Our Ref: 2023/520926
File No: R/2022/24/A

SSD-32275057 – Redfern Mixed Use Co-living Development – Advice on RtS

2 TYPICAL DIRECTIONAL PRIVACY SCREEN TO COURTYARD FACING UNIT PERSPECTIVE

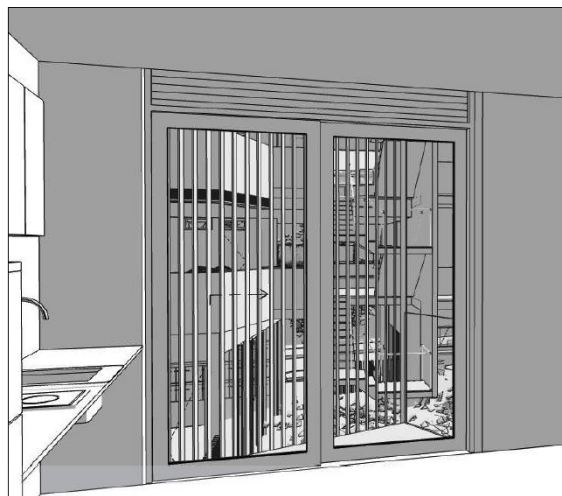
Although the proposal has improved the separation distances provided in part to the northern of the courtyard, there are still substantial ADG separation and visual privacy deficiencies when compared to the ADG objectives for habitable-to-habitable interfaces of up to 4 storeys which requires 12m (as shown below).

The reliance upon landscaping to provide privacy between circulation corridors which are very close to room windows is questioned as genuinely mitigating visual privacy concerns. It would not assist acoustic privacy to rooms.

Given these corridors are no longer proposed to provide natural cross ventilation / ventilation benefits (as discussed further below) their continued inclusion in the scheme is questioned. The reliance upon the proposed privacy screening (as shown below) may mitigate some visual privacy concerns to other rooms and open common circulation but comes at the expense of outlook amenity from each room's only window.

- The size of the courtyard is to be further increased to improve the amenity of rooms reliant on this aspect, by removing a number of internal courtyard facing rooms.

- Operable external privacy treatments are recommended to courtyard rooms to enable user controlled privacy and solar access to those rooms that can receive it, instead of fixed battens which reduce outlook amenity to achieve some degree of visual privacy.
